**APPROVED MINUTES OF THE REGULAR SESSION OF THE
BUILDING BOARD OF APPEALS OF THE CITY OF ANN ARBOR
FEBRUARY 12, 2009 - 1:30 P.M. – COUNTY BUILDING, 200 NORTH MAIN
STREET - LOWER LEVEL CONFERENCE ROOM, ANN ARBOR, MI 48104**

189 **C-3 BBA09-007 – 305 Brierwood Street**

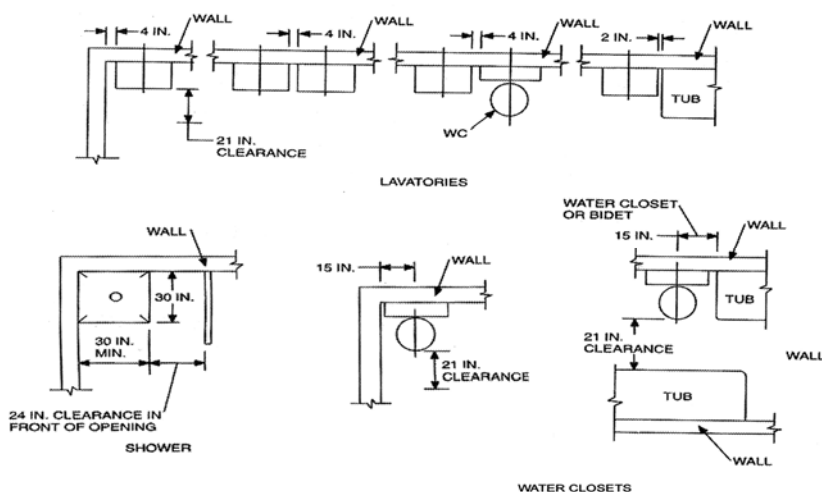
197 The applicant is requesting a variance from Section R307.1 of the 2003 Michigan
198 Residential Code that requires that toilet fixtures spaced per the following diagram.

201 Petitioner is remodeling an existing bathroom. The bathroom does not meet code with relation
202 to fixture clearances. The bathroom is very small and there is not the required 4-inch clearance
203 between the toilet and the lavatory. The original bathroom walls were not changed.

204
205 Mr. Matt Nicholas was present to speak on behalf of the appeal. He stated they have moved
206 the toilet flange from the sidewall where it was previously to permit the 15 inches required. As
207 inspected, the toilet spacing was just under that. We can realign that, but probably will still fall
208 short of what is required by Code.

218
219 K. Winters – Previously there was an additional four inches or greater? (Nichols – In the
220 previous fixtures there was a greater space but closer to the closet wall.) So that would have
221 been a non-compliant dimension as well. (Correct.)

222
223 P. Darling – What is that dimension from? (A. Savoni – From the edge of the tank to the edge of
224 the lavatory. He has the smallest tank and sink you can probably buy.)

229
230 Moved by P. Darling, Seconded by Reik, “**In Regard to Appeal Number BBA09-007, 305**
231 **Brierwood Street, from Section 307.1 and Figure 307.1 of the 2006 Michigan Residential**
232 **Code to allow the replacement of existing fixtures with new fixtures and allow a minimum**
233 **of 3 inch dimension from the edge of the sink to the edge of the toilet tank. We find this**
234 **to be equivalent to what the Code requires, given the conditions of the current**
235 **remodeling project.”**
